LiDAR Quality Assessment Report

Project ID:
Sussex and Warren County LiDAR Processing

Project Description:
This task is for the processing of a high resolution LiDAR data set of 577 square miles in Sussex and Warren counties New Jersey, to obtain a bare earth DEM suitable for inclusion in the National Elevation Dataset.

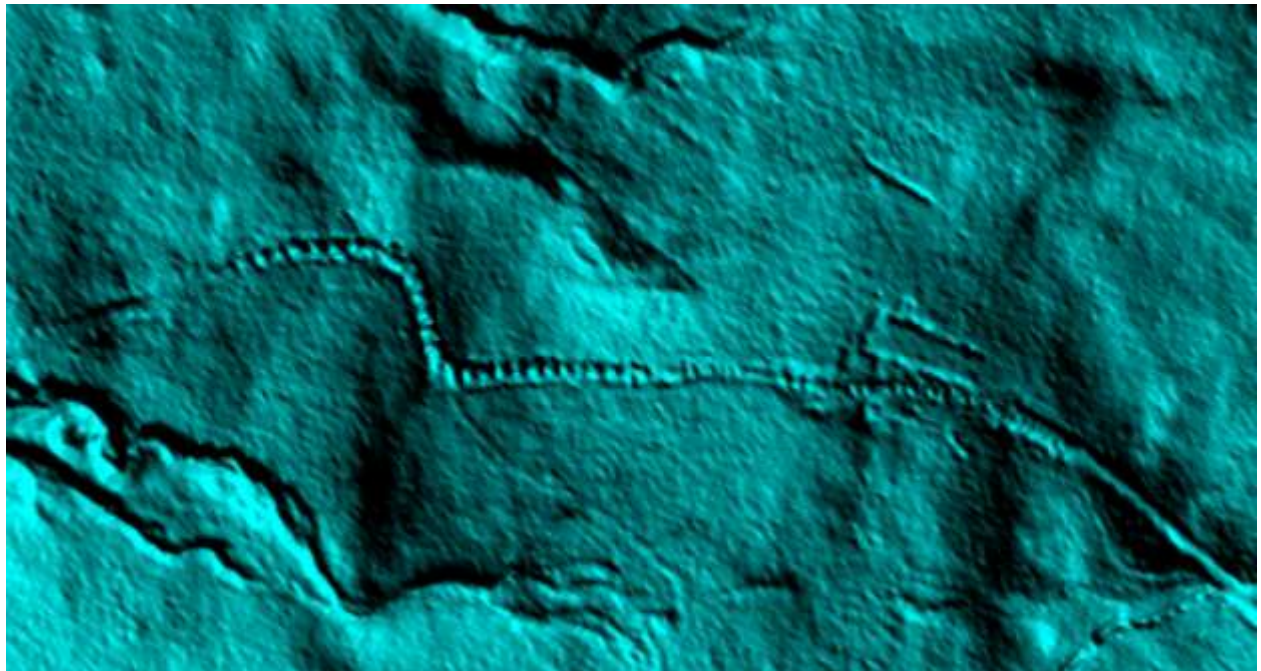
culverts have been removed throughout project. It is not required to remove culverts in hydro-flattened projects.

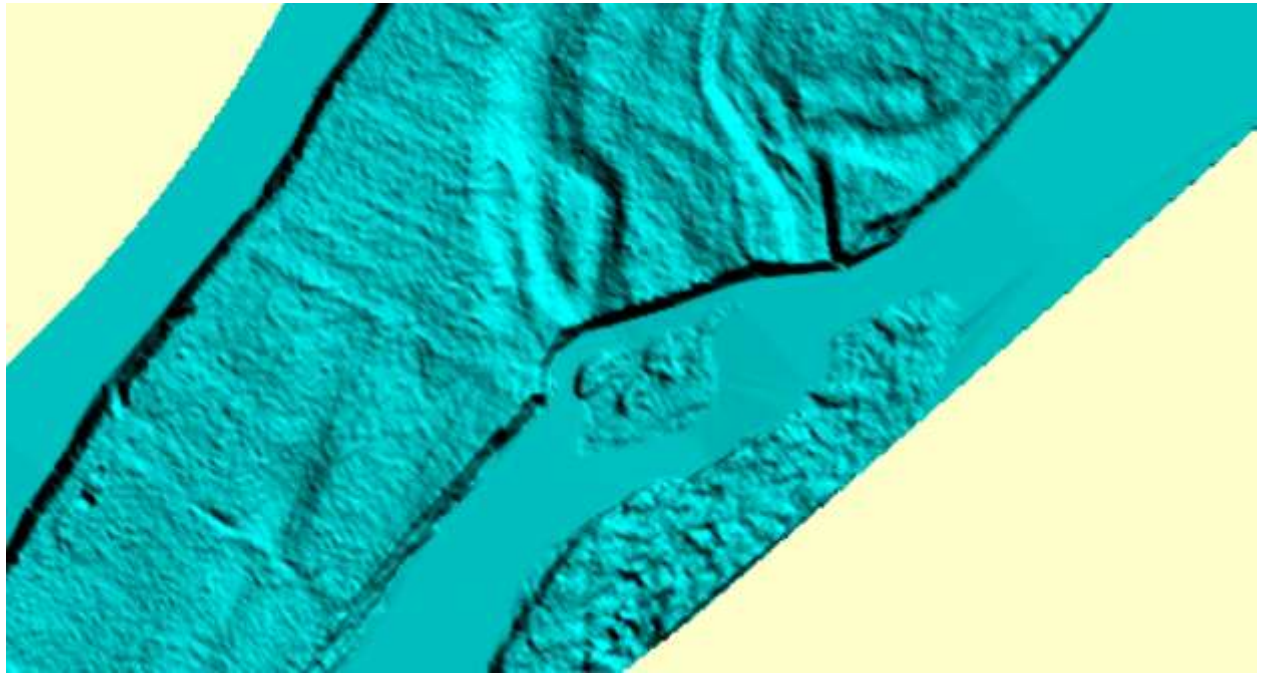
bad or missing data on exterior tile edges
edges have been corrected by vendor

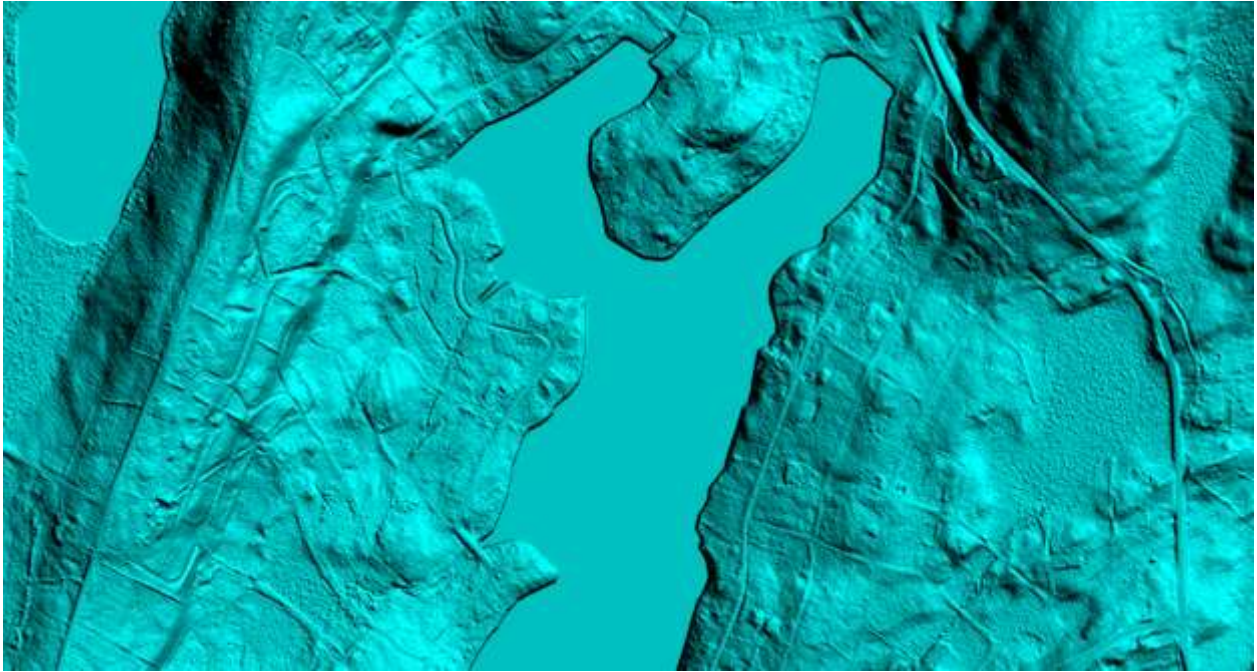
floating island
corrected by vendor

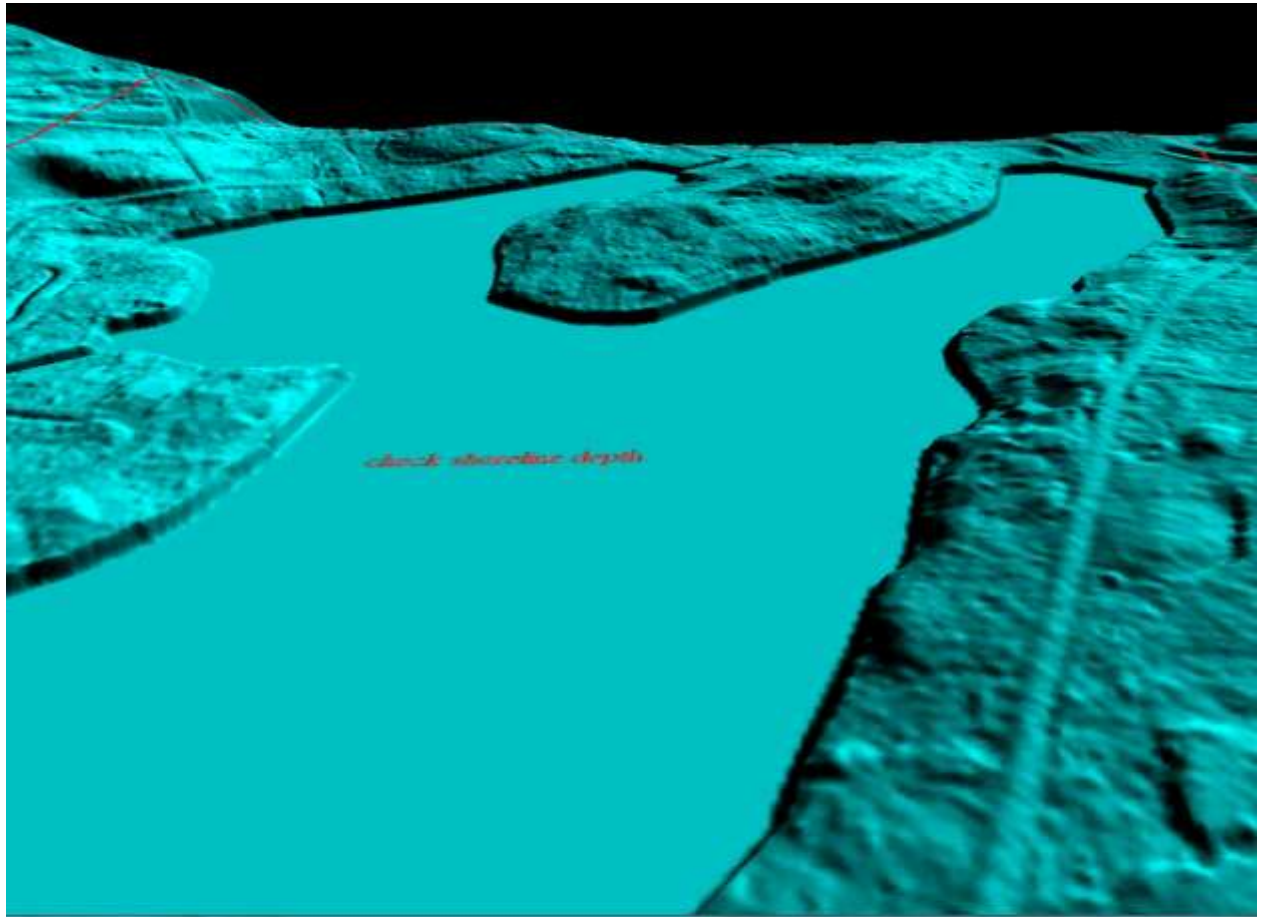
steep/cookie cutter affect shoreline
corrected by vendor
